TO:	T10 Membership
FROM:	Paul A. Suhler, Quantum Corporation
DATE:	9 March 2006
SUBJECT:	T10/06-061r1, ADC-2 Model for Devices with No ADT Ports

These changes are with respect to ADC-2 revision 3.

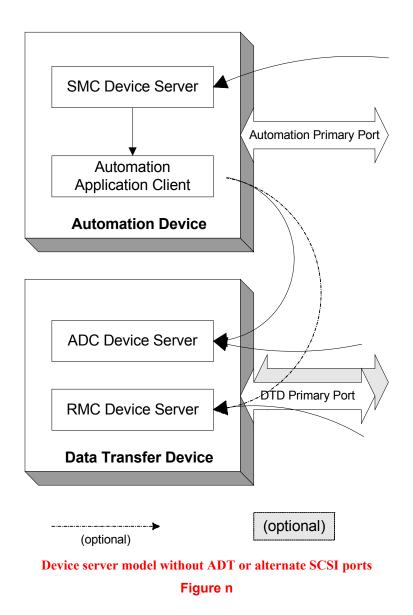
Instead of the automation ports shown in figures 2 and 3, the automation and DT devices may pass SCSI requests and responses via their primary ports. The ADC device server shall be accessible as a logical unit through the DT device primary port. The RMC device server should be accessible as a logical unit through the DT device primary port, and may be an asymmetric logical unit (see SAM-3).

Figure n shows an example of this communication, in which the automation primary port is a SCSI target/initiator port. If enabled (see 6.2.2.4.2), the RMC device server shall be accessible as a logical unit through the DT device primary port. The ADC device server shall be accessible as a logical unit through the DT device primary port. There may be no need for a local SMC device server, because the SMC device server is directly accessible via the automation device's primary port.

Add following Figure 3:
